Environmental impact statement : proposed Clarence and
Wolgan Valley Coal mines : supplementary report for Coalex
Pty Ltd.

**PROPOSED CLARENCE and WOLGAN VALLEY
COAL MINES**

COALEX PTY LTD

September 1975

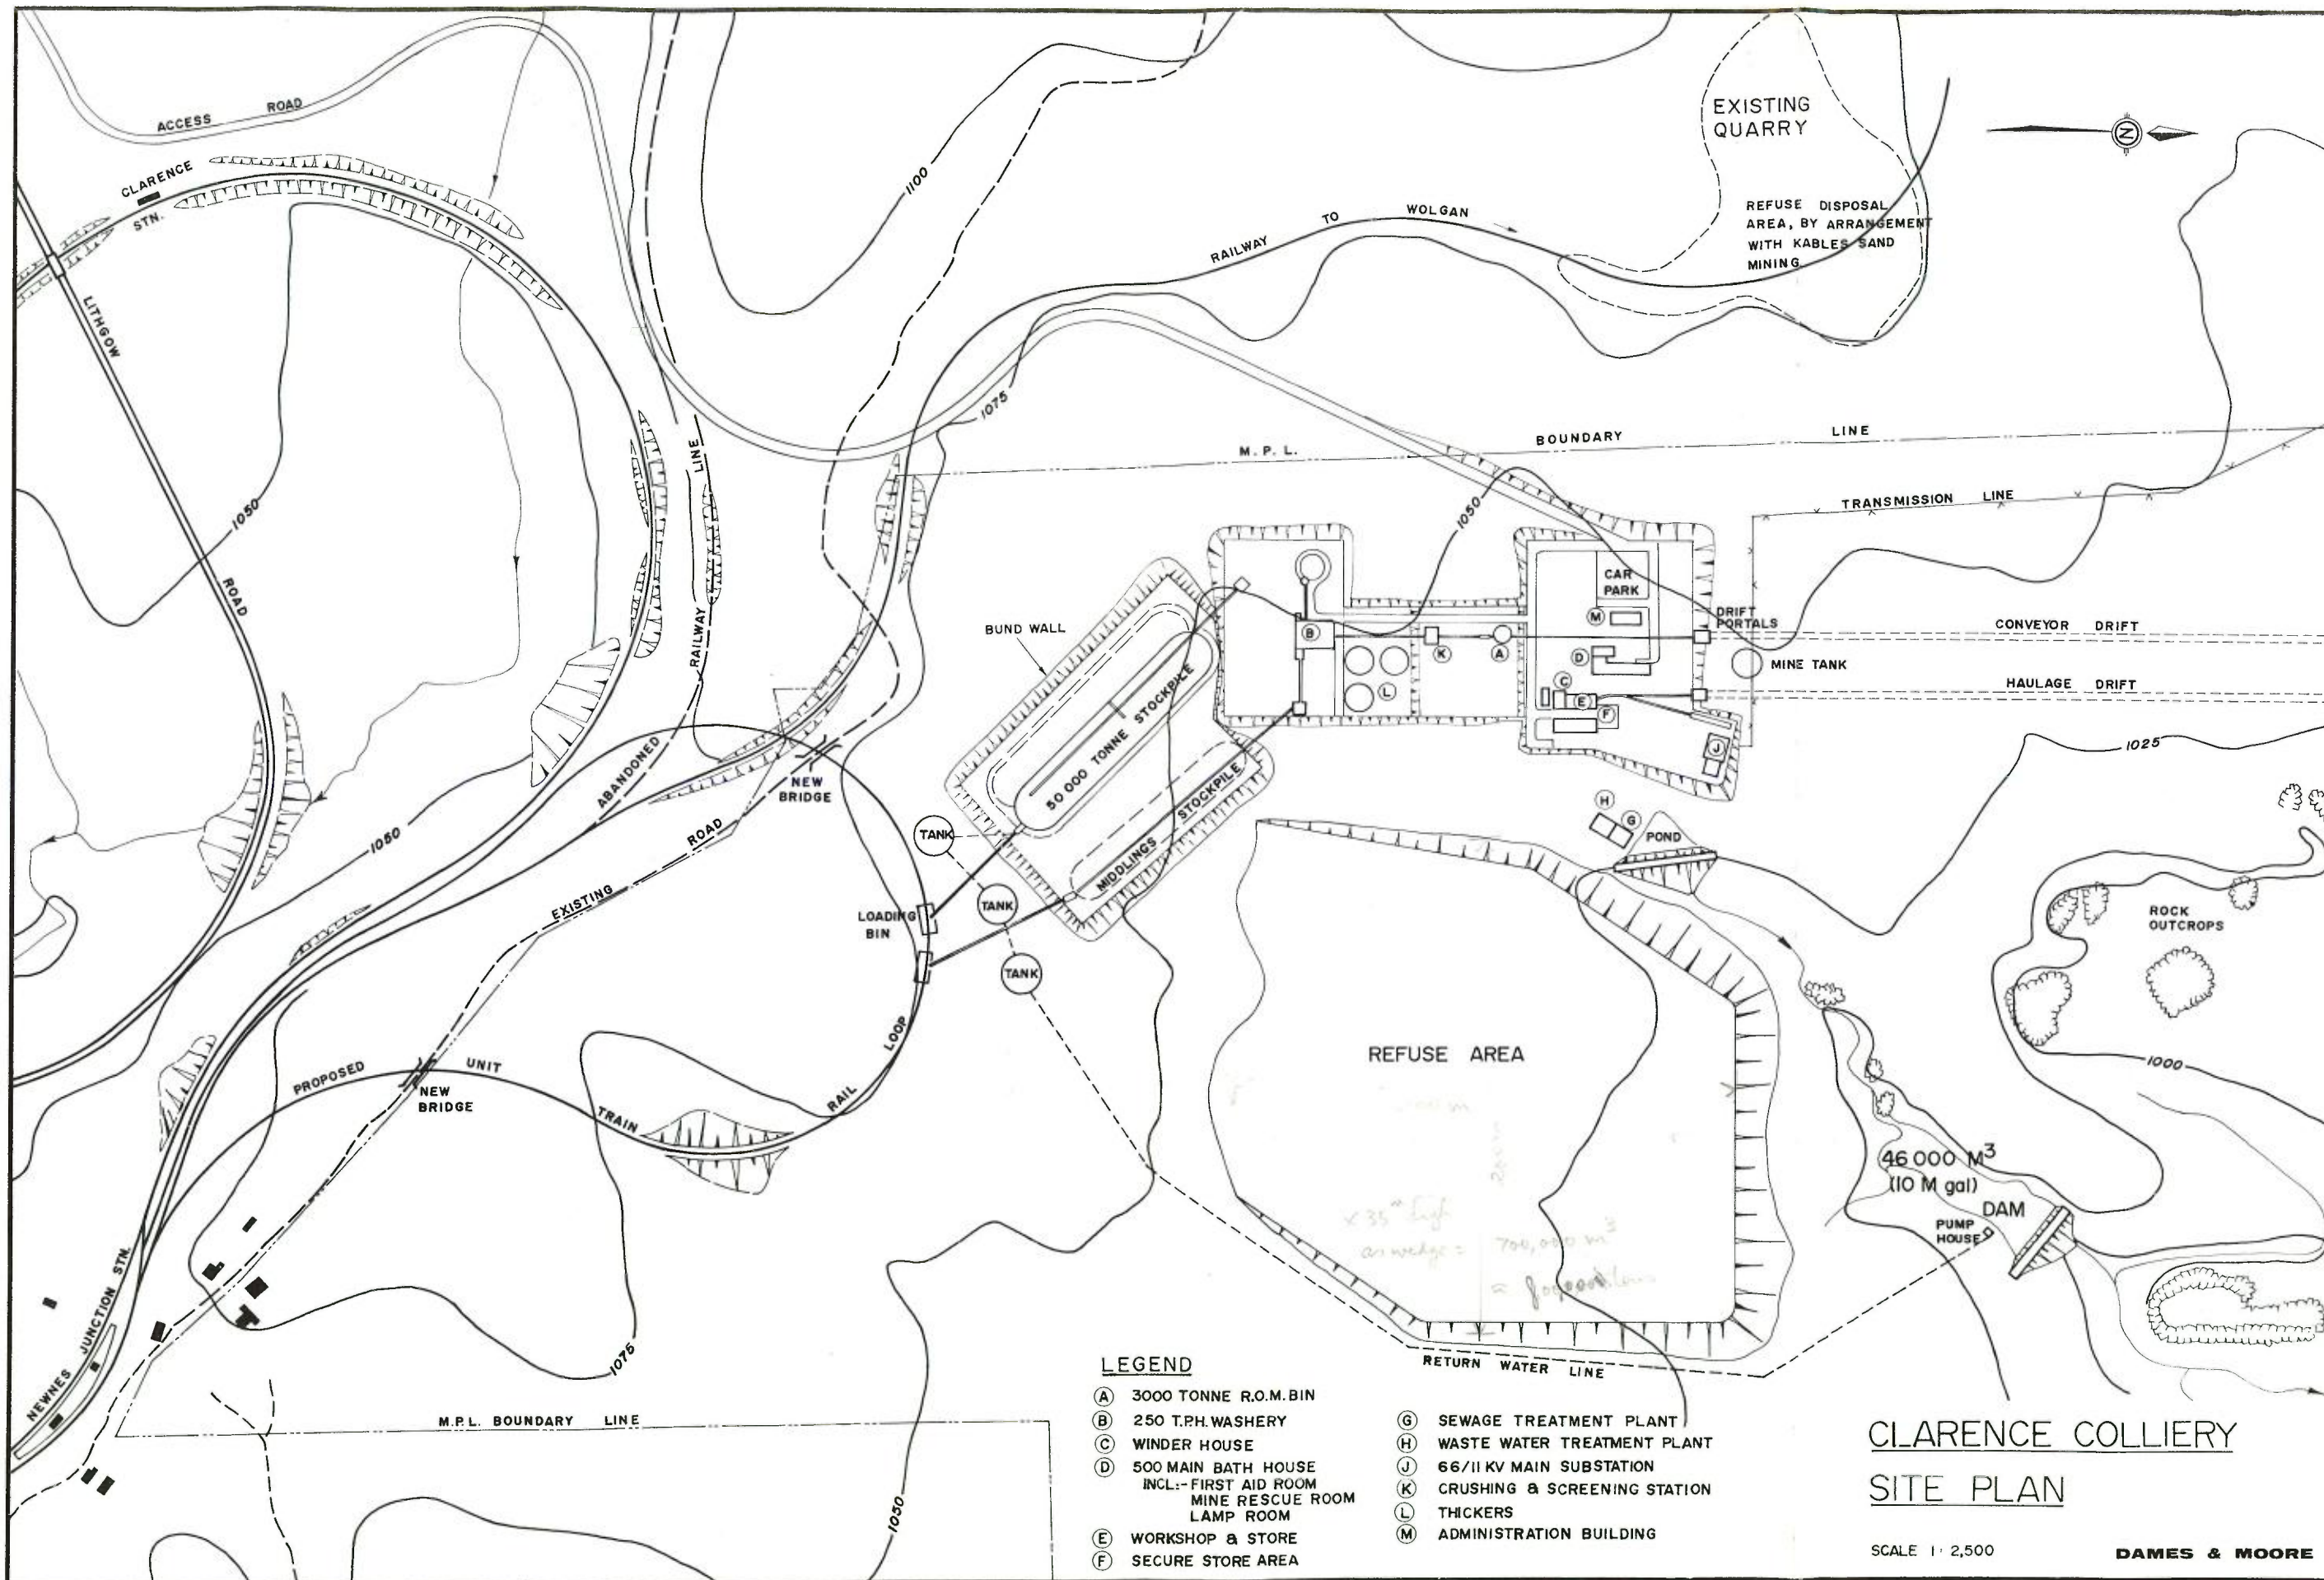
cliff map?

CLARENCE COLLIERY
PROPOSED REFUSE
DISPOSAL SCHEME

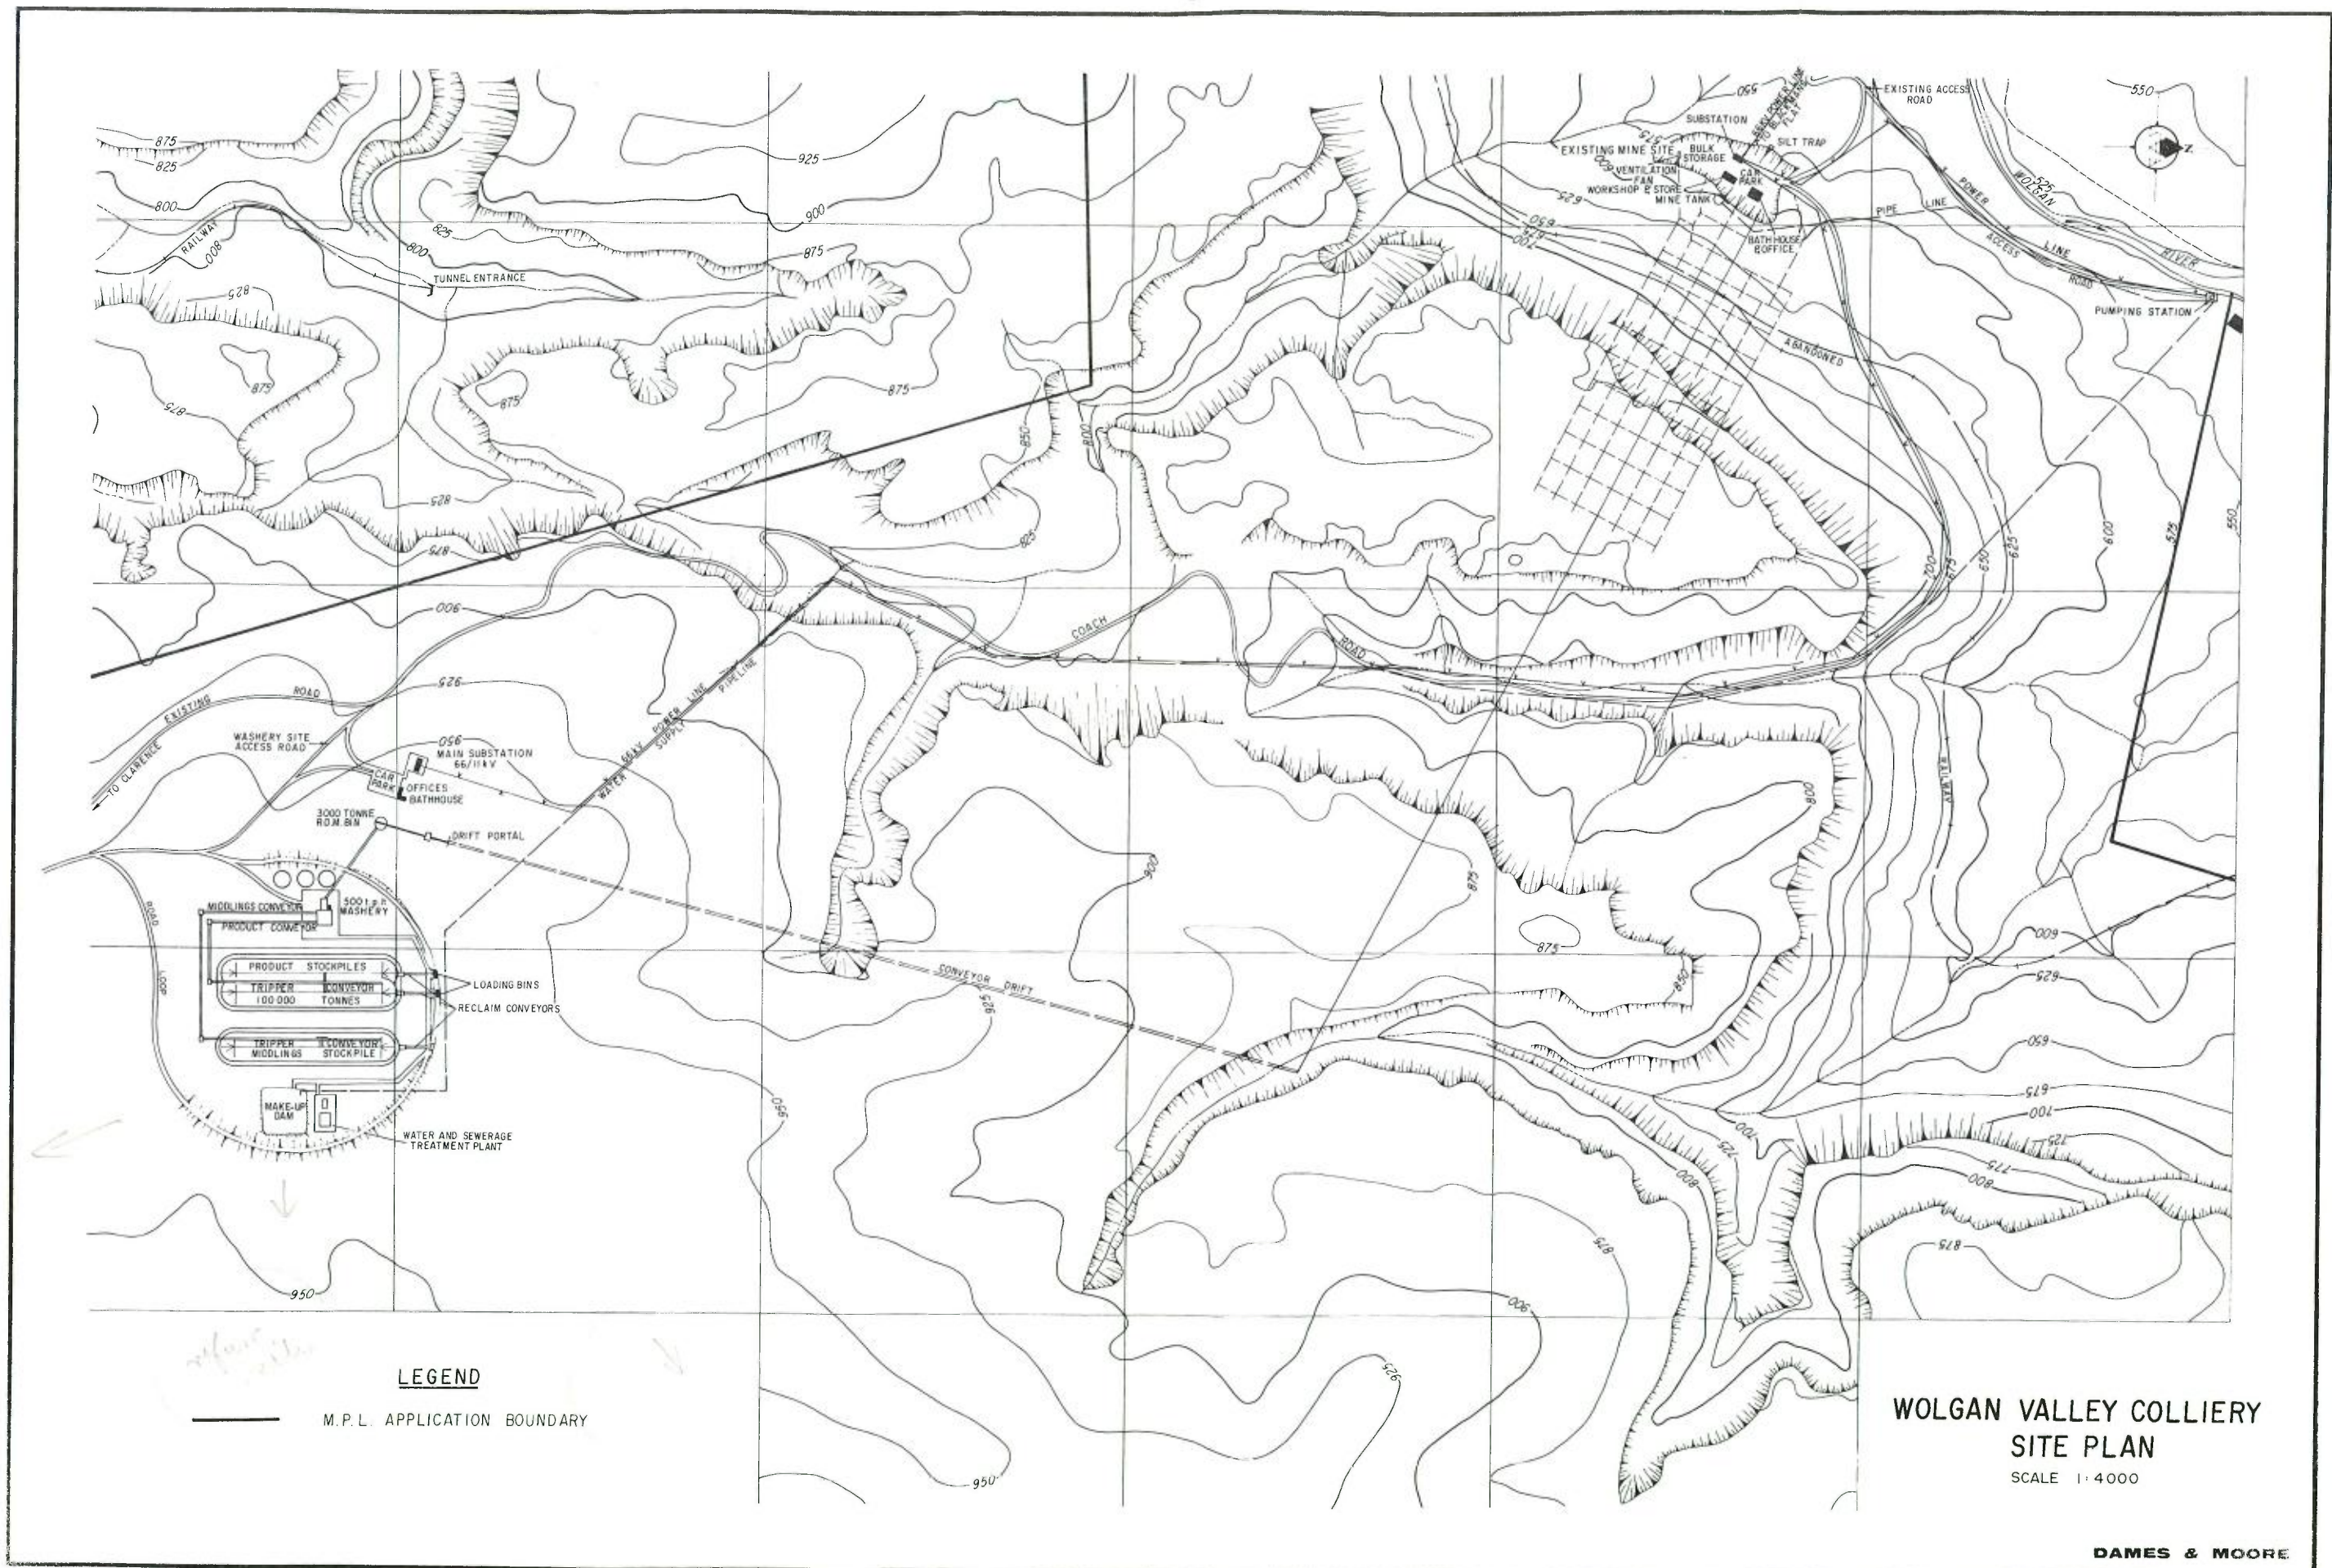
Need guarantee that it is an engineered structure
